Ref 2026 - 1c - 4b Hampstead Hill Gardens

## **Re: 4b Hampstead Hill Gardens**

I have accessed the Camden Council Planning Portal to review the documents posted for the planning application to demolish and rebuild 4b Hampstead Hill Gardens, as instructed, to carry out a structural review of the proposal.

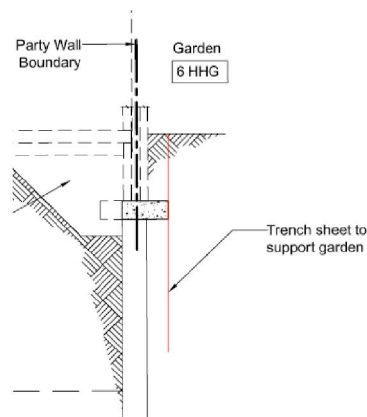
The current Temporary Works proposals show that the existing masonry walls built off the strip footings on the Party Wall line are to be retained but cut back to the Party wall line. As these walls retain the ground additional temporary works will be required to allow this to happen. In addition, the drawing incorrectly references the size of the piles (300mm) and thickness of foundation (225mm). The drawing also indicates that the piles extend significantly below the proposed Basement SSL which is not the case based

on the record drawings, which indicate a toe level at approximately 72.700, as described above.

The cavity wall leaf is to be removed for the full height as noted in the stage drawing and waterproofing is to be provided. This will result in the remaining part of the cavity wall having to resist the wind loads that it has not been subjected to previously and where as one could expect a cavity wall to withstand the wind load on a floor by floor basis this is not the case in this situation. The condition of the wall is not known and nor is the adequacy of any tie in of the wall into the floors which is required to resist any wind load, so the assumption made that no damage will be caused is suspect. This is a major flaw in the planning of the work which will put 4a at risk both during the demolition phase when one leaf is removed but also in the longer term during construction under wind and stability loading for an unknown period of time or season. In addition the construction of the wall below DPC is shown on the record drawings as both cavity and solid construction. To reduce a solid wall thickness by half over a significant length will inevitably create damage to the retained portion of the party wall.
